Office Action Summary	Application No. 10/593,849	Applicant(s) OLOVSON, GUDMAR	
	Examiner KAMI A. BOSWORTH	Art Unit 4177

DETAILED ACTION

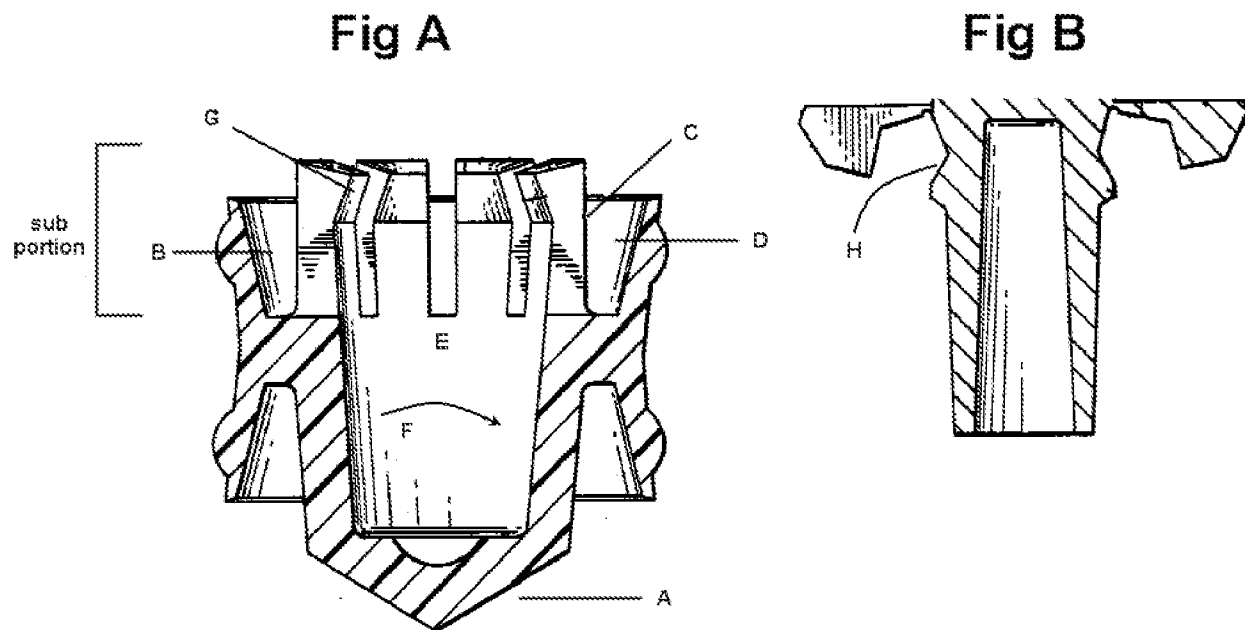
12. Re claim 1, Hammett discloses a syringe 10 (Fig 1) of non-reusable type comprising: a container 11 (Fig 1), a rod 16 (Fig 1) cooperating with said container, a piston unit 30 (Fig 1) inserted in and reciprocally disposed in said container, and a needle 14 (Fig 1); the rod being, by the intermediary of an axial displacement movement, reciprocally disposed in said container and displaying in its end portion, enclosed by the container, a first coupling device 23 (Fig 3) within a two-part coupling

arrangement (Fig 3), whose second coupling device 47 (Fig 7) is related to said piston unit; and where said two coupling devices assume a mutual cooperation and an active position while the piston unit is, by the movement of the rod, displaced from a position, closely adjacent said needle, to a position distal from said needle and gradually brings said coupling devices towards and into an inactive position, while the piston unit is, by the movement of said rod, displaced from the position distal from the needle towards and/or to the position closely adjacent said needle, the two coupling devices permitting, in an inactive position, an axial movement of the rod to take place without cooperating with said piston unit (Col 2, Lines 25-36); wherein, said second coupling device is provided with a piston unit related means 34 (Fig 7), rotary coordinated with a piston A (best seen in Fig A below) within a piston unit; said unit displays a sub portion (best seen in Fig A below) adapted for a rotary cooperation with a recess B (best seen in Fig A below) in said piston unit; said means displays a supporting sliding surface C (best seen in Fig A below), facing towards a sliding surface D (best seen in Fig A below) provided on said piston unit where in any event one of said sliding surface is of a planar configuration; said means also displays a portion facing inwardly into the container with a sliding surface E (best seen in Fig A below) associated with the coupling device and given a configuration and a curvature F (best seen in Fig A below) associating to a cylindrical helix and/or to a conical helix, whereby said portion of the means facing inwardly into the container, displays a support surface G (best seen in Fig A below), oriented transversely of a centre line related to said means, and that said support surface is cooperating with a further support surface H (best seen in Fig B below), each

adapted with a covering area to form surfaces which have a total area less than a cross section of said container and in said inactive position, said support surfaces are disposed laterally related and free from one another for a free passage of the support surface associated with the rod to pass the support surface associated with the piston (Col 5, Lines 63-68; Col 6, Lines 1-4).
